Work Order ID 98146

Item Name: Replacement Skidtube

DRAWING NO. D2650	TITLE 206/407 SKIDTUBE ASSEMBLIES	REV. F	DART AEROSPACE LTD ENGINEERING ORDER		D.E.O. NO. D2650-F-1	SHEET NO. SHEET 1 OF 1	SCALE NTS
DRAWN <i>[Signature]</i>	CHECKED A.P.	MFG. APPR. <i>[Signature]</i>	APPROVED <i>[Signature]</i>		DE APPR. <i>[Signature]</i>		
DATE 12.10.12	DATE 12.10.22	DATE 12.10.22	DATE 12.10.22		DATE 12.10.22

CHANGE C'BORED WELDED CROSSBOLT SPACERS TO SWAGED SPACERS

DETAIL G

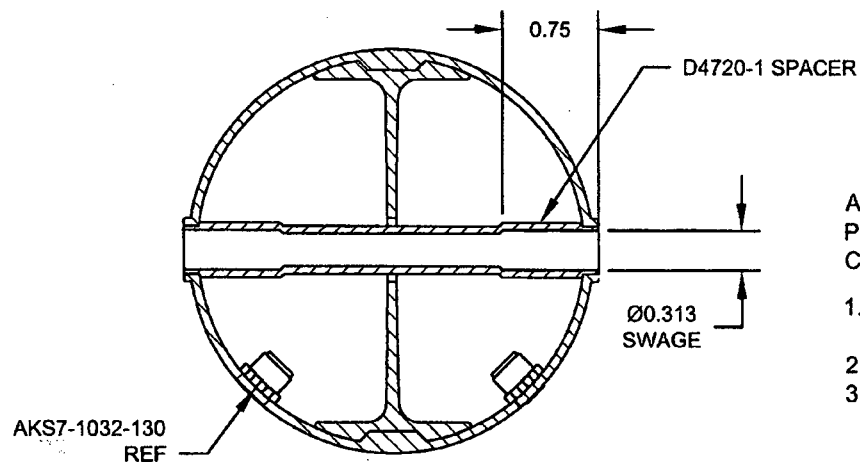
WAS:

17	18	19	23	D2649	CROSS BOLT SPACER
----	----	----	----	-------	-------------------

ADD DETAIL G BELOW, WHICH IS THE SAME SECTION VIEW AS DETAIL D OF DWG.
C'BORED HOLES ARE **NOW SWAGED** PER DETAIL G BELOW. FOR THE Ø0.375 HOLE THAT IS NOT C'BORED, WELD PER DETAIL D OF DWG (SEE AMENDED DETAIL B FOR REFERENCE).

FOR Ø0.375 HOLES ONLY

FOR HOLES THAT ARE CURRENTLY C'BORED ONLY
NOT TO SCALE

DETAIL B

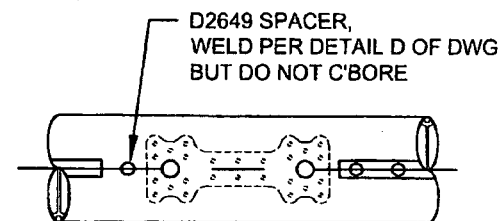
AMENDMENT TO DETAIL B
NOT TO SCALE
